DESIGN MEMORANDUM NO. 14.1

RECREATION FACILITIES and PUBLIC USE AREAS

Little Goose Reservoir

SUBJECT: Little Goose Project, Design Memorandum No. 14.1, Recreation
Facilities and Public Use Areas, Little Goose Reservoir

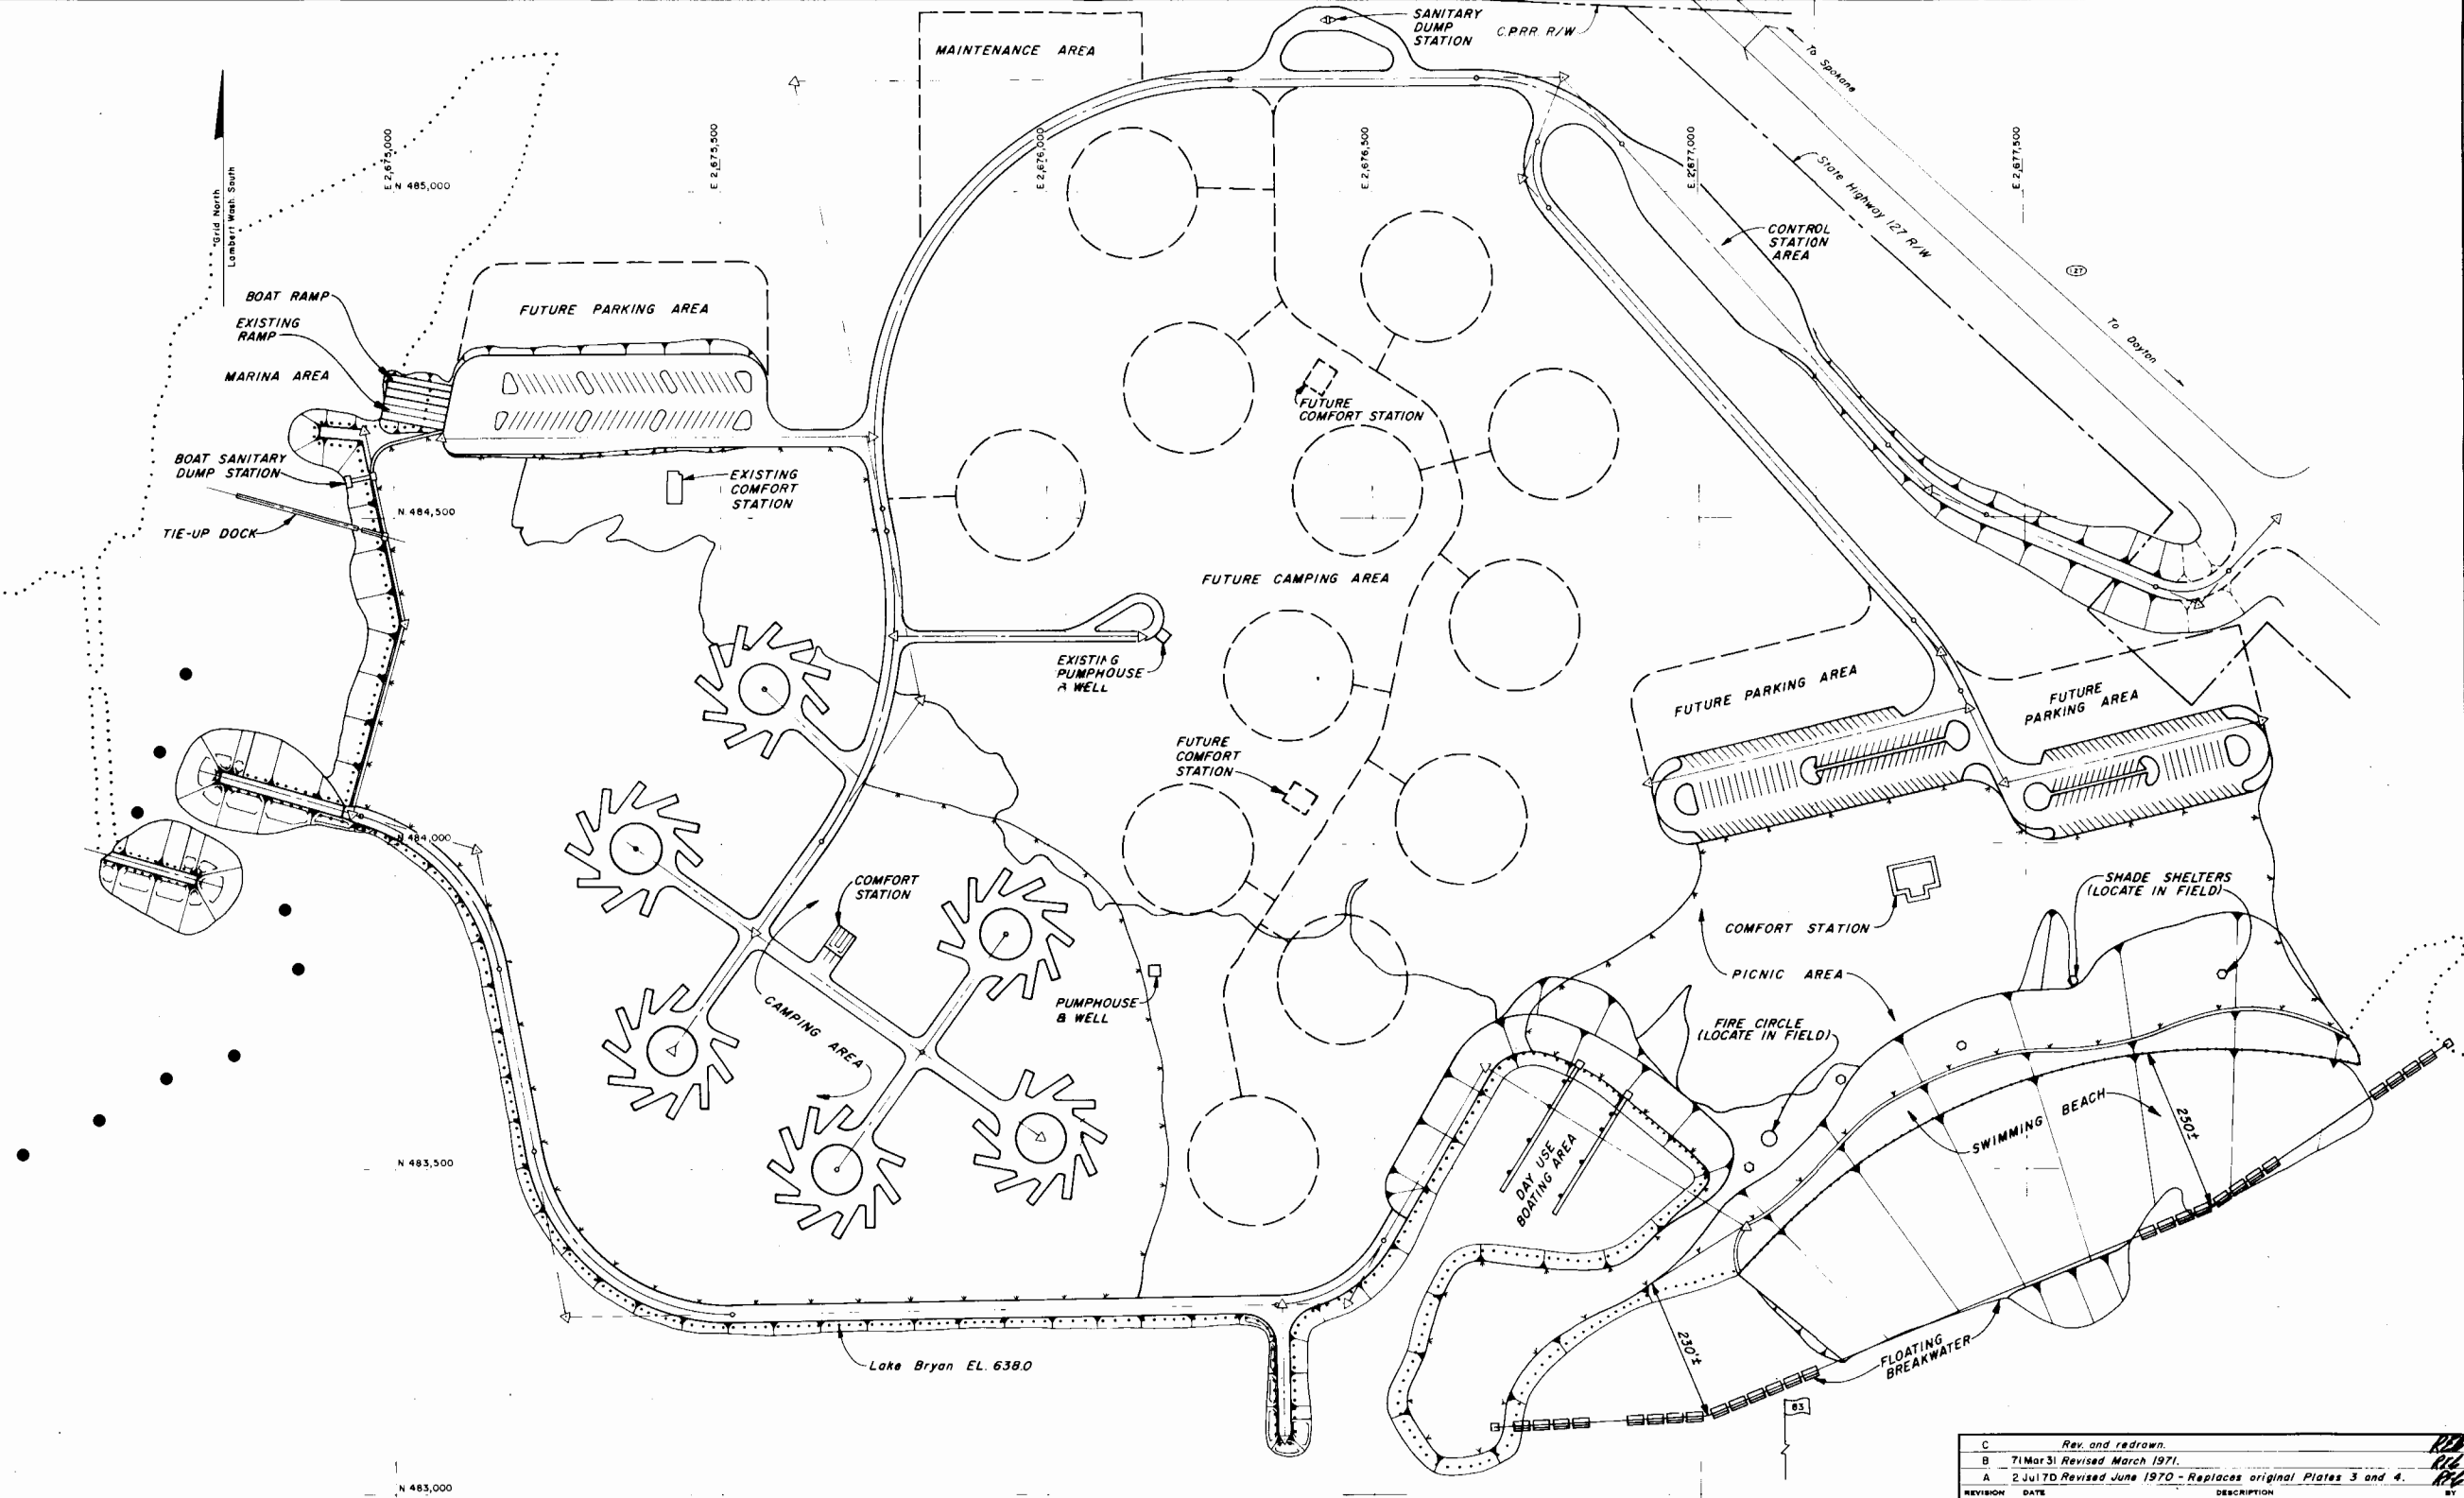
(1) Plate 3 dated 27 May 1969 indicated 120 units in 2 future camp areas. No future units are shown on the revised plan. If such units are planned for the future, their tentative location should be shown on the revised plates 3 and 5.

(2) Clarify whether the existing comfort station at approximately N485,550-E2,675,450 is to be removed or retained.

(4) Wave data presented on Plate 4 suggests slope protection may be necessary along the camping area shoreline. Evaluation of erosion under present pool conditions would provide information on revetment requirements.

(1) Plates 3 and 5 have been revised to show location of the future camp sites. Revised copies are inclosed for insertion in your copies of the design memorandum.

a. The parking area layouts had been increased from the original design memorandum layout in order to comply with State of Washington requirements. This revised capacity is reflected in revised Plate 3.

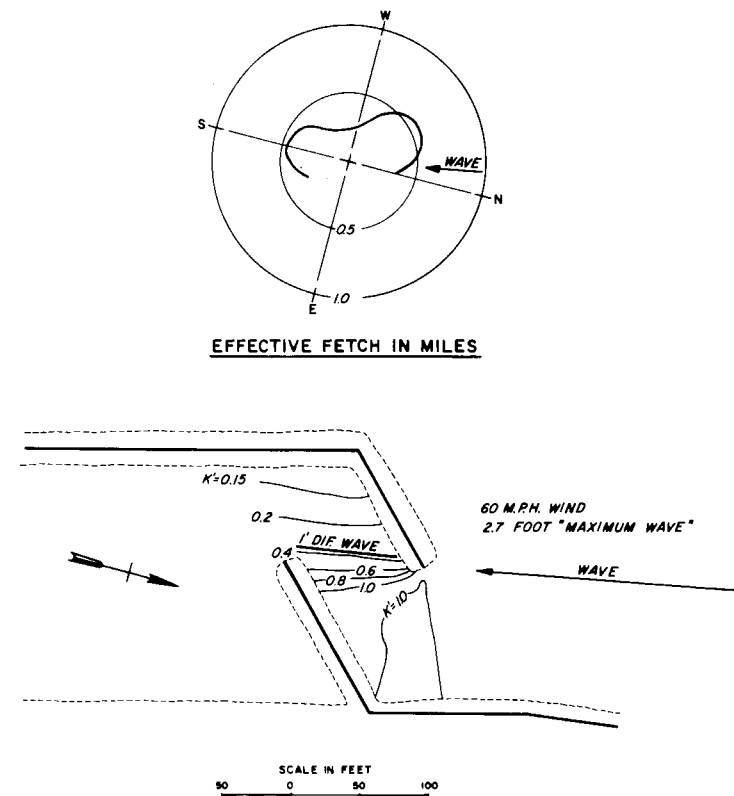
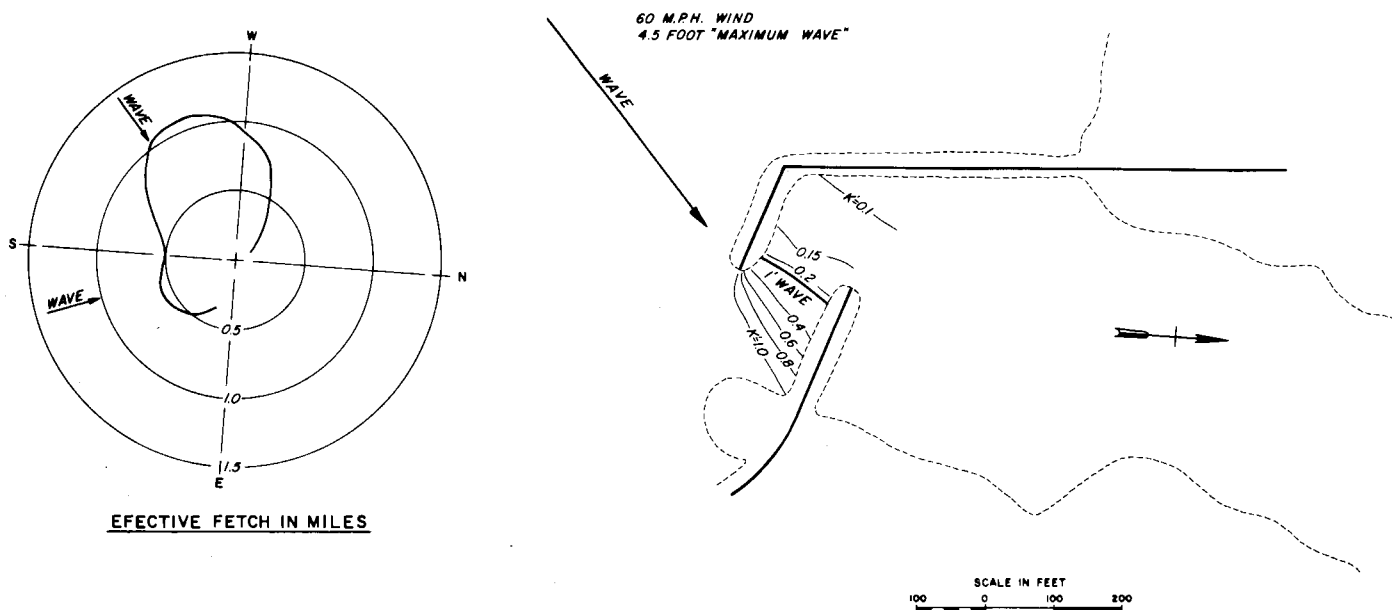
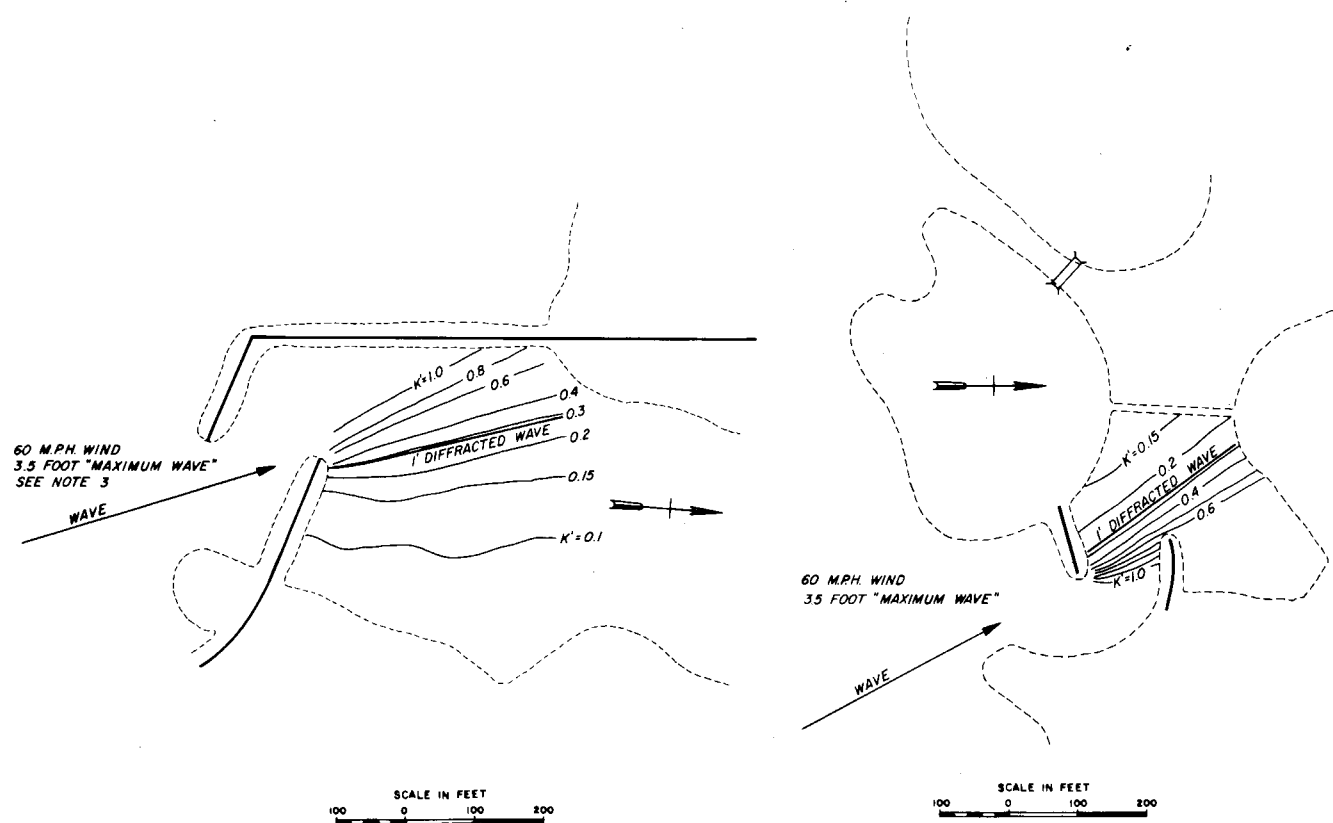
Paragraphs 1a and 1c. Reference is made to Note 2, Plate 4, DM No.
14.1 which lists wind data and design assumptions. Information presented
does not appear to be based on the same design assumptions. District
should review design data to be assured the proposed breakwater plans
will provide the designed protection.

(2) Drawings of wind wave studies for Central Ferry and Boyer Sites are included on new Plate 4 and show expected wave heights. The currents could be analyzed by model studies; however, the change in stage and the mean sectional velocity at River Mile 105.4 for the initial hydraulic capacity at Lower Granite 10,000 cfs, and the future hydraulic capacity 120,000 cfs are as follows:
